Jones Gillam Renz Architects

Irving Lofts – Historic Rehabilitation – JGR Proj 25-3479

ADDENDUM NO. 1

PROJECT INFORMATION

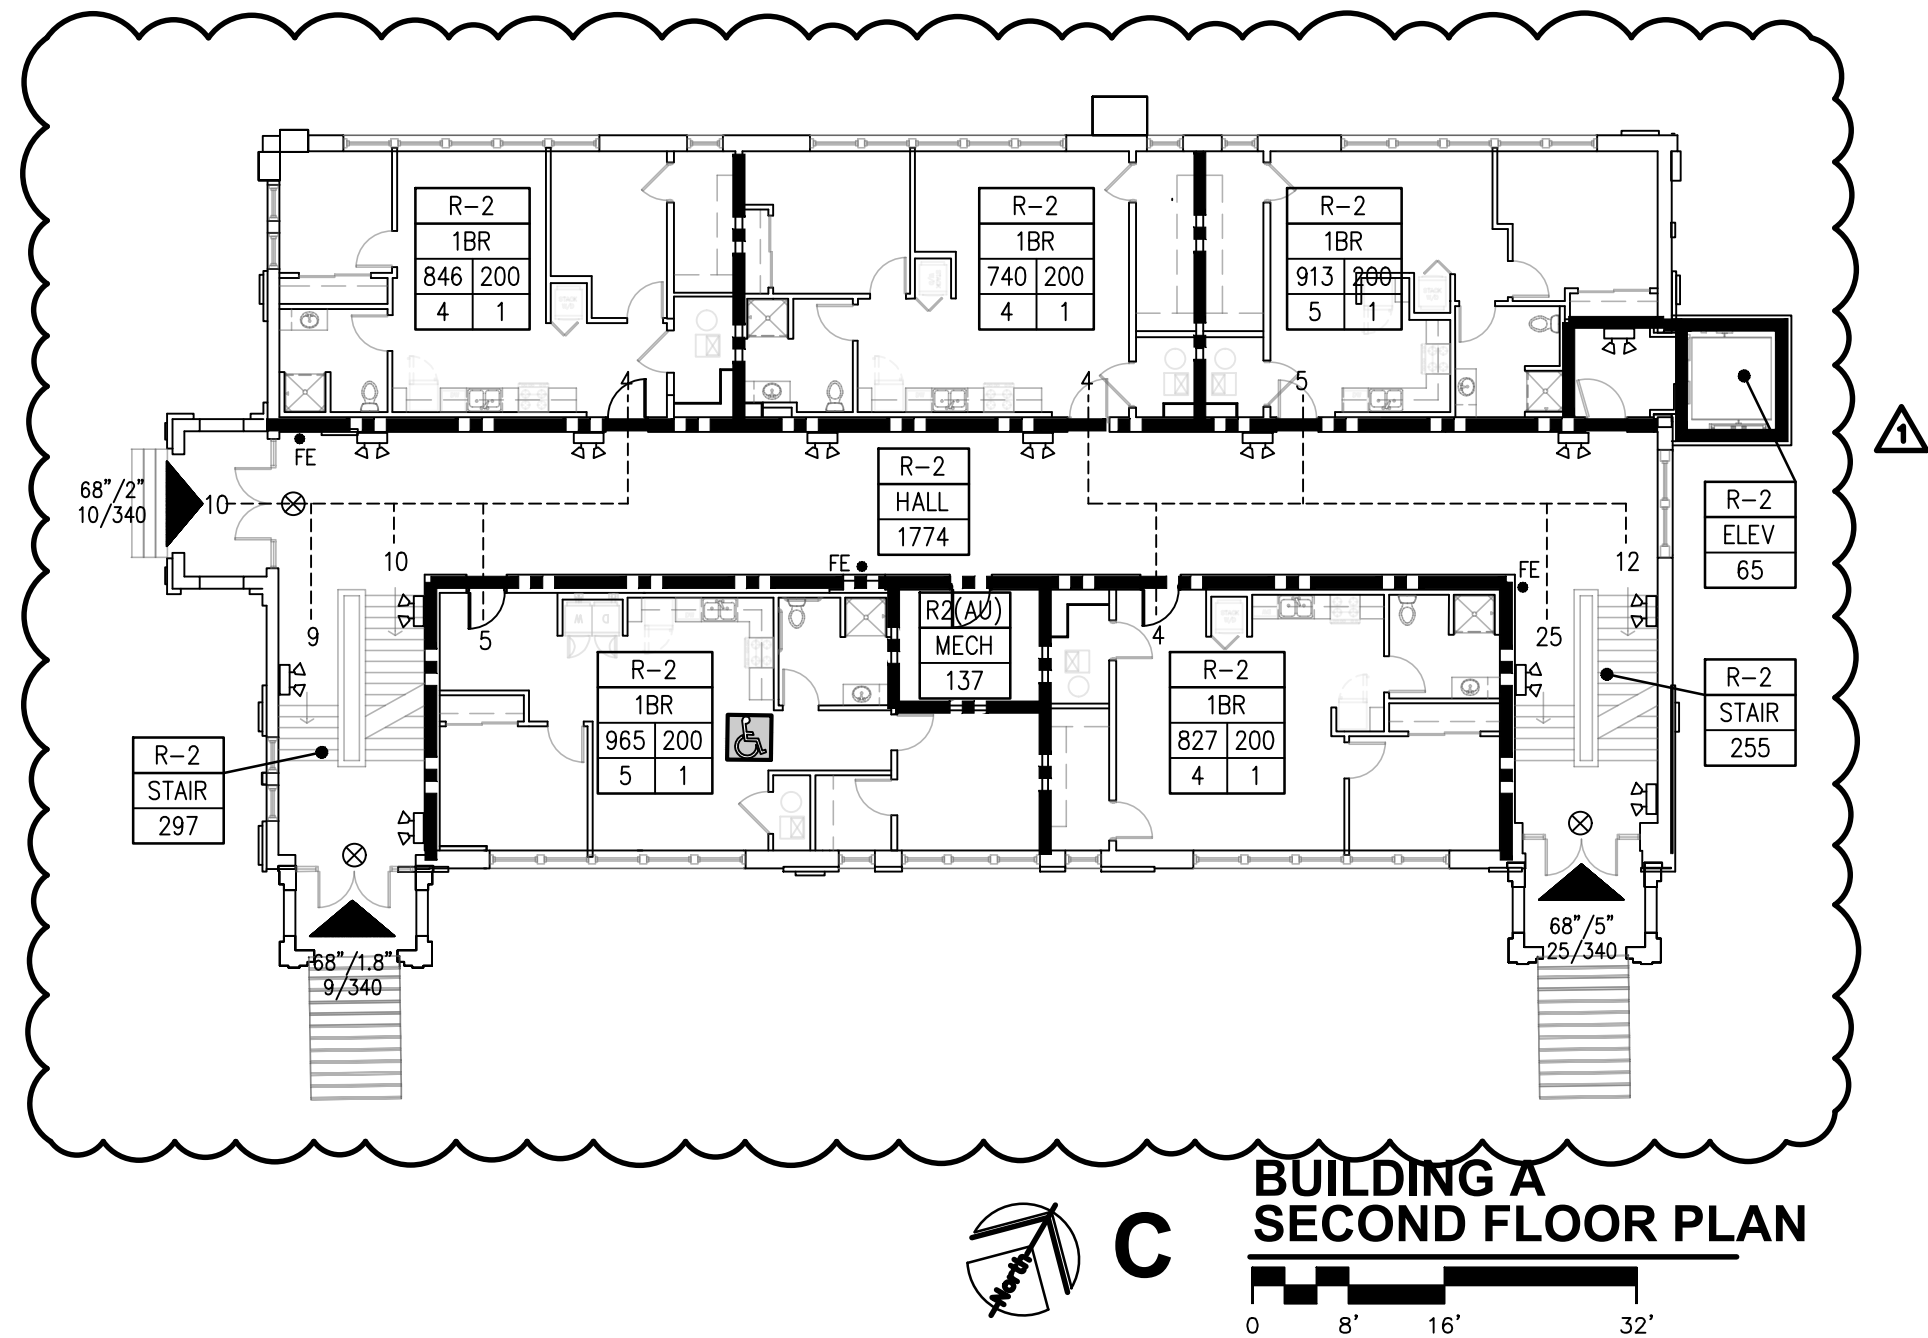
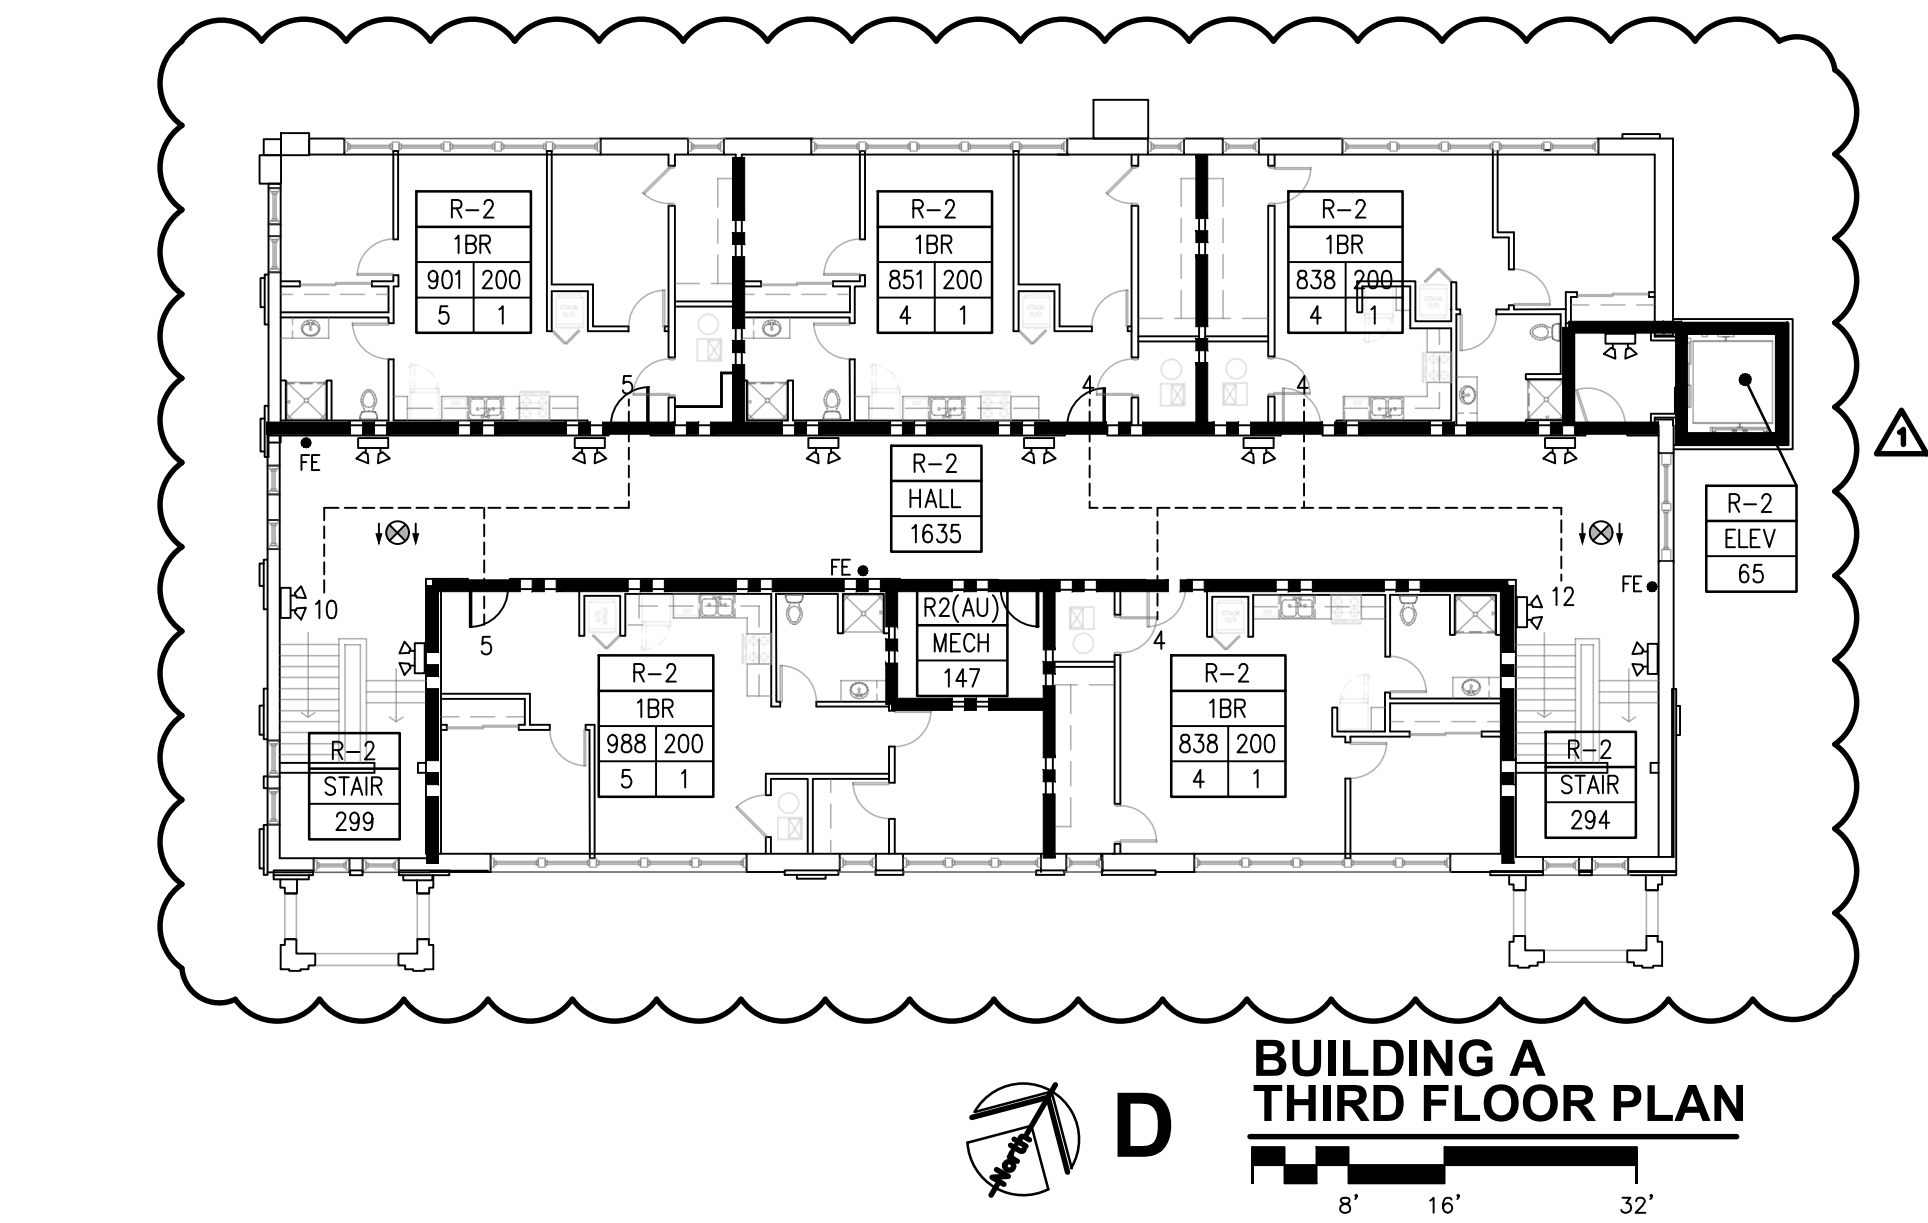
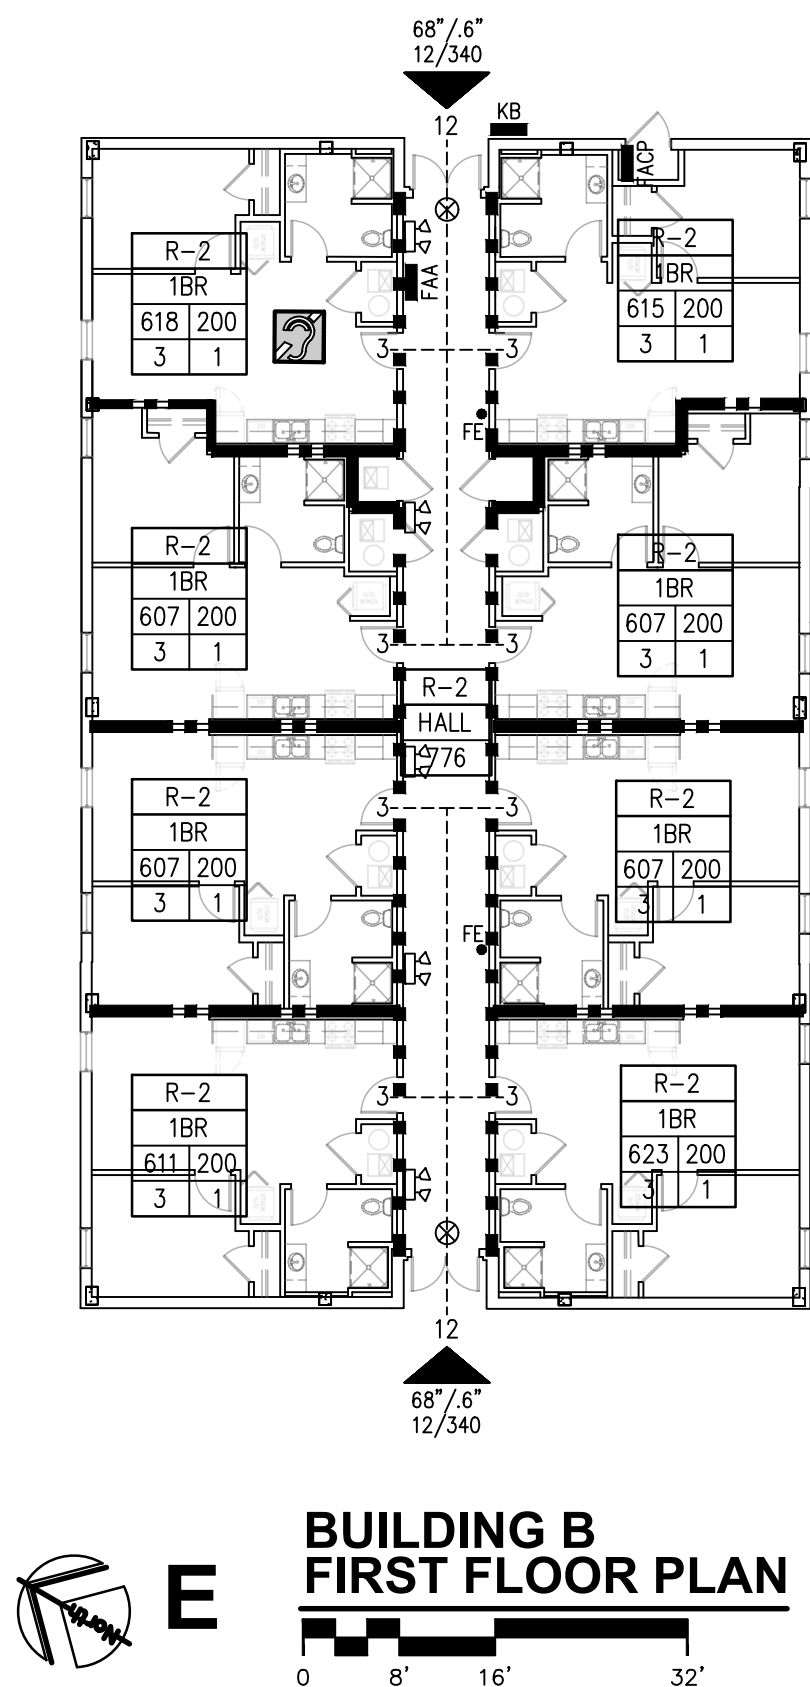
1. CFP1 – Building A: Construction Type has been revised to III-A in lieu of III-B. Allowable and actual building area have been revised. Basic allowable height has been revised. Fire Resistance Ratings and Construction chart has been revised.

CFP2

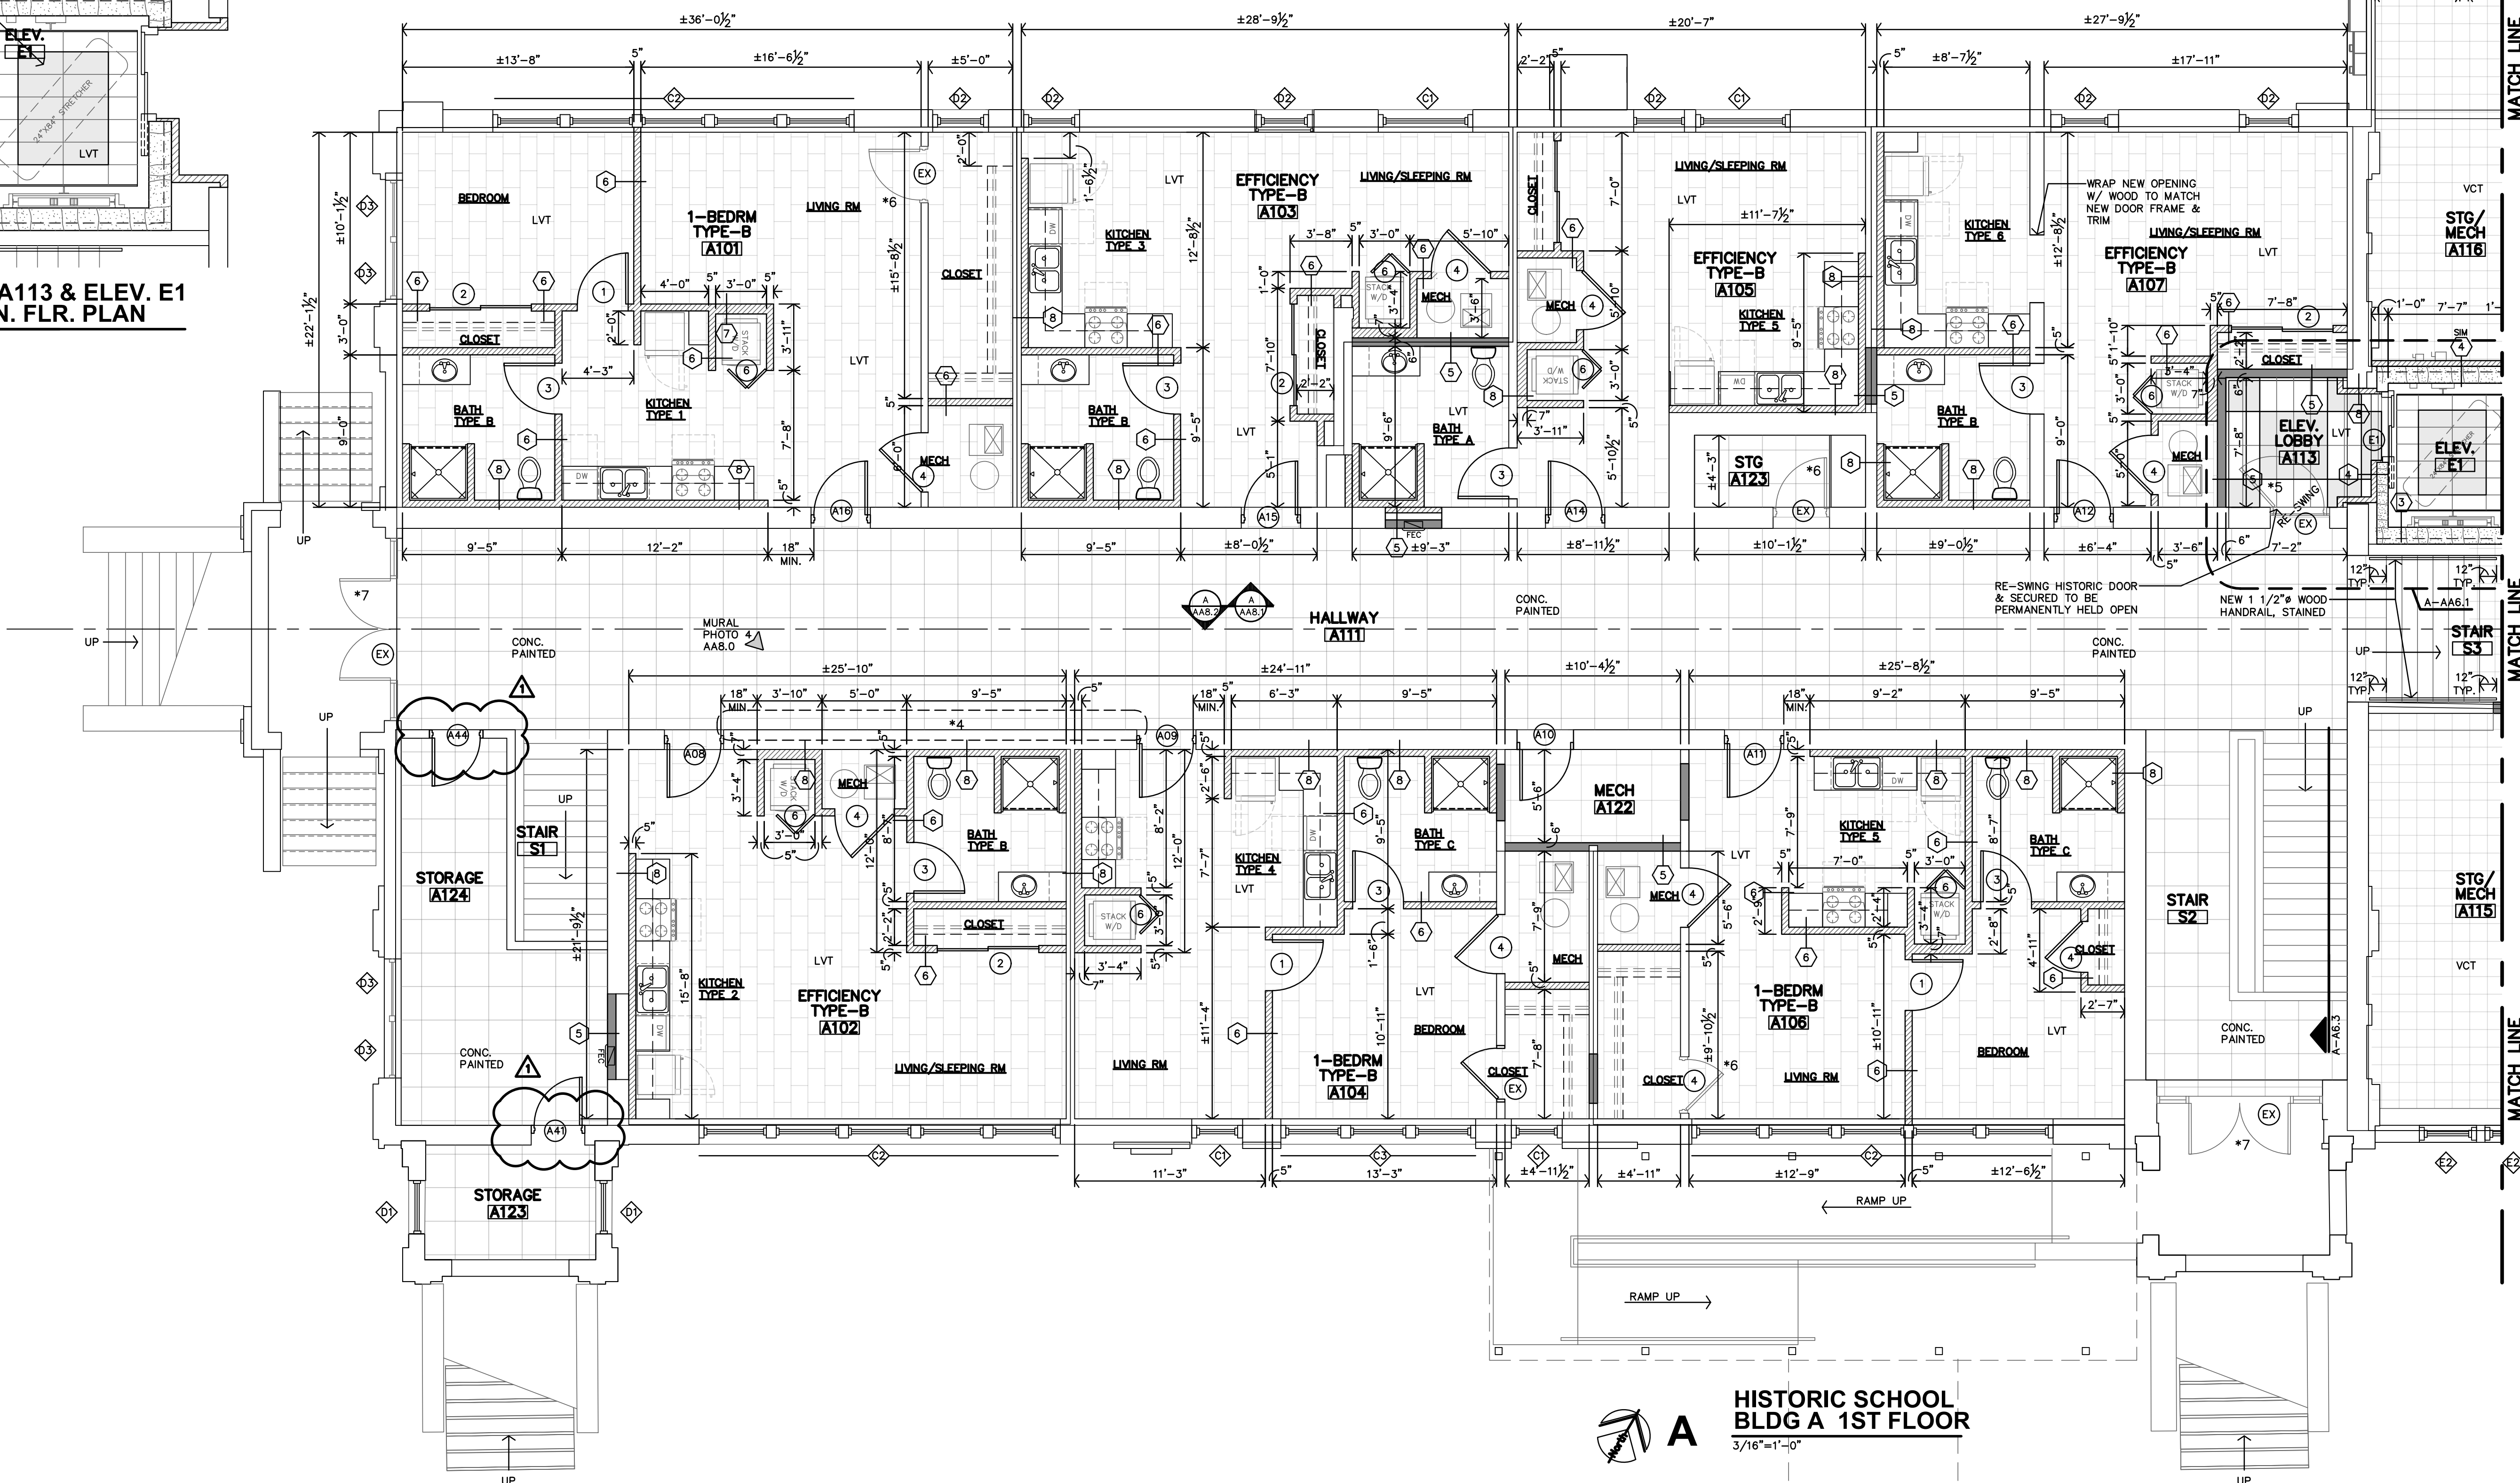
2. CFP2 – Building A: Corridor walls at the ‘historic school’ have been revised to 1-hr rated walls with 45-min openings.
3. A2.0 – Buildings A, B & C: Apartment General Notes – Sheet references in Notes 6 & 7 have been revised.
